MEETING NOTICE – SITE REVIEW COMMITTEE

5. DISCUSSION AND ACTION – 575 Centerline Dr., HB-524-4; 4,310 SF Commercial Building with Associated site Improvements (Page 3)

FROM: Todd Gerbers, Director of Planning and Code Compliance

BUILDING ELEVATION - SOUTH

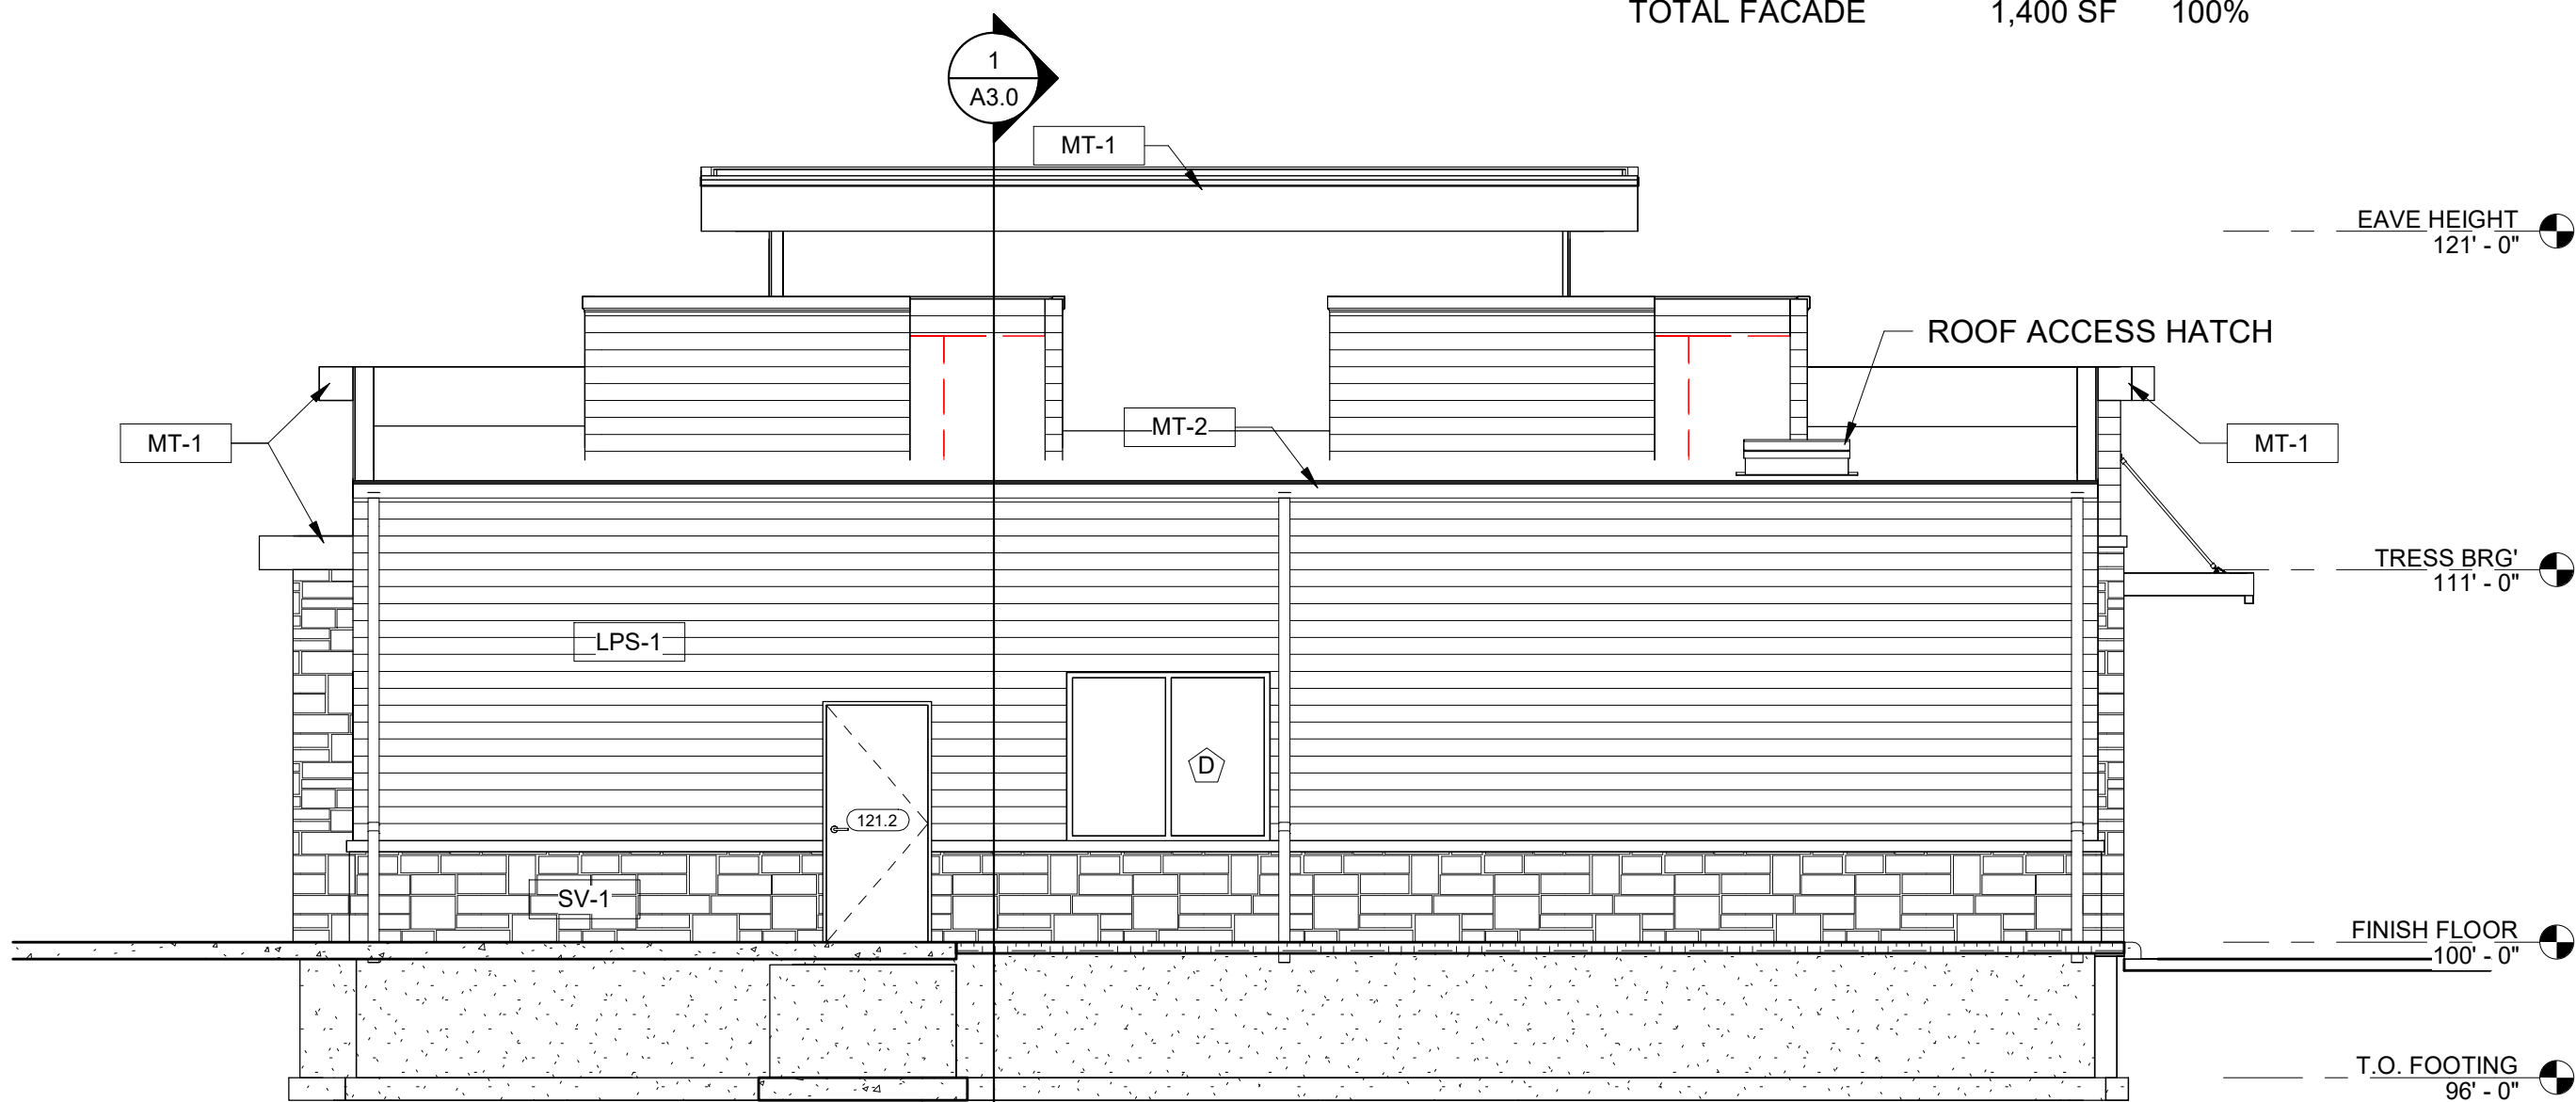
Section 5, Signage: Sign location is noted on the front elevation of the proposed building. No other signage is noted on the submitted plans. Signage details are required to be submitted to Village Staff for approval prior construction of signage and permitting.

5. The proposed wall sign, as noted on the building elevations drawing in this submittal, shall be submitted to Village Staff for review and approval prior to permitting and installation. Any other proposed signage will require review and approval by the SRC prior to permitting and installation.
